CITY OF AUSTIN – DEVELOPMENT SERVICES DEPARTMENT
SITE PLAN APPLICATION – MASTER COMMENT REPORT

CASE NUMBER: SP-2020-1025C
REVISION #: 0
CASE MANAGER: Clarissa E. Davis
UPDATE: U0
PHONE #: 512-974-1423

PROJECT NAME: BOAT DOCK & BULKHEAD
LOCATION: 3002 SCENIC DR

EV 8 On the ESC sheet, hatch the area where the LOC enters into the CWQZ.

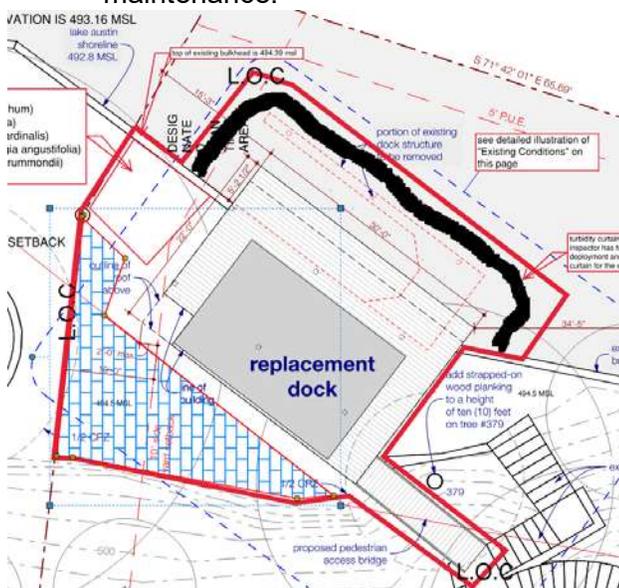
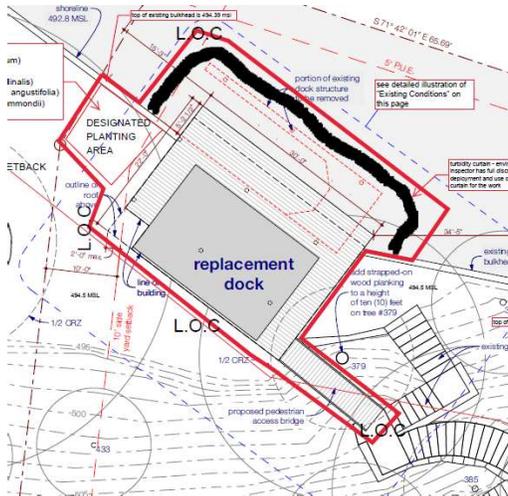
Update 1 Comment not cleared.

1. Explain what work is proposed in the blue hatched area. If no work is proposed, remove this area from the LOC.
2. If work is proposed and the area stays in the LOC, hatch the area and add a callout note stating: "This area requires native grassland seeding and planting per City of Austin Standard Specification 609S.6, including topsoil and seed bed preparation, temporary irrigation, and weed maintenance."

Agent Reply EV8 > Please see the revised LOC which excludes the "blue hatched area".
